Bear Lahai Roi Subdivision 2022 Addition KPB File 2022-089 Segesser Surveys / Smardo Nikiski Area

ITEM 6 - BEAR LAHAI ROI SUBDIVISION 2022 ADDITION

KPB File No.	2022-089
Plat Committee Meeting:	July 18, 2022
Applicant / Owner:	Jeffrey and Caroline Smardo of Kenai, AK
Surveyor:	John Segesser / Segesser Surveys
General Location:	Kenai Spur Highway, North Woods Street, Nikiski

STAFF REPORT

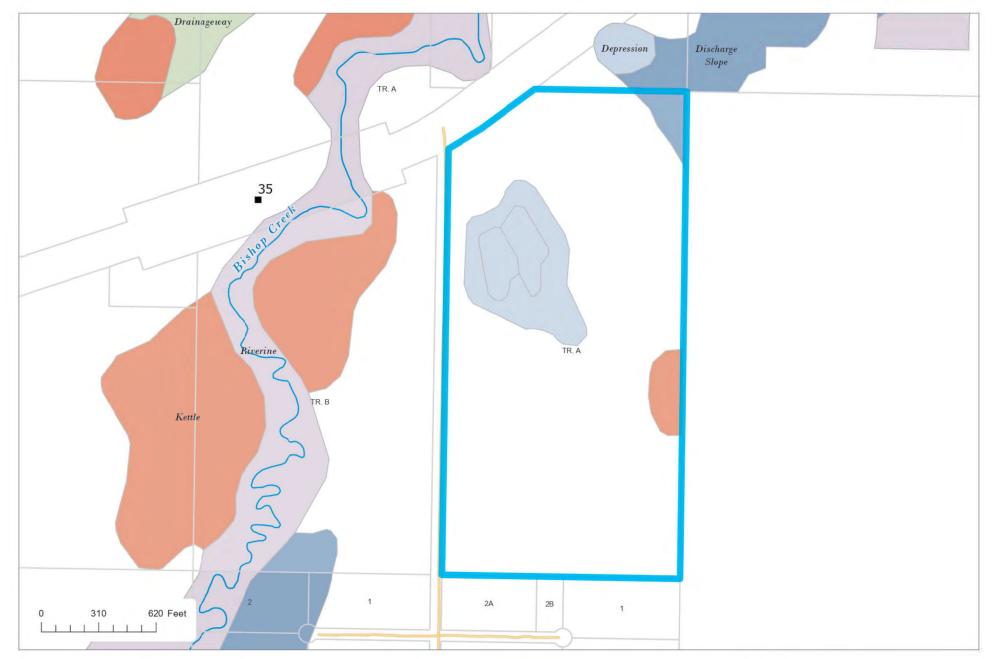
<u>Site Investigation:</u> Some low wet areas are present within the subdivision. *Staff recommends* the low wet areas be depicted and a wetland determination note be added to the final plat.

Per KPB GIS data, there appears to be a few areas with steep terrain present. **Staff recommends** terrain exceeding 20 percent slopes be shown on the final plat and if right-of-way dedications are required in areas with terrain steeper than allowed by code, centerline profiles be submitted for review.

<u>Utility Easements</u> The parent plat granted 10 foot utility easements adjacent to the dedicated rights-of-way. The proposed plat will be carrying over the 10 foot utility easements and granting 20 foot utility easement within 5 feet of the side lot lines. Due to the scale of the plat, **staff recommends** a typical setback/utility easement depiction be added to the plat that include the side lot line easements.

Several recorded easements are present and noted on the plat. Several of the easements contain information regarding the location and several of them were depicted on the parent plat. **Staff recommends** any easement granted by document be shown on the plat with a label referring to a plat note or state the document creating the easement.

Staff recommendation: The location needs revised as this is within the E1/2 NE1/4 or just NE1/4 is sufficient. The owner's first name is misspelled according to the Certificate to Plat and the deed within the Certificate to Plat. Update the acreage.

- **Staff recommendation:** The Kenai National Wildlife Refuge is located to the east of the property. This should be noted and depicted on the neighboring property.

- **Staff recommendation:** The Kenai National Wildlife Refuge boundary should be depicted and a label added
- G. The status of adjacent lands within 100 feet of the proposed subdivision boundary or the land status across from any dedicated rights-of-way that adjoin the propose subdivision boundary, including names of subdivisions, lot lines, block numbers, lot numbers, rights-of-way; or an indication that the adjacent land is not subdivided:

- **Staff recommendation:** Lot 2 Block 1 located south of the subdivision has been replatted and should be revised for a corrected depiction and labeling. A plat has been submitted for the property to the west of North Woods Street. Prior to creating the mylar the status of the property should be verified to determine if a new depictions and labels will be required.

The plat note numbers need to be revised.

Plat note 4 is not required unless right-of-way dedications are required.

Plat note 11 should include the Assignment recorded as document 2017-000-133-0, KRD.
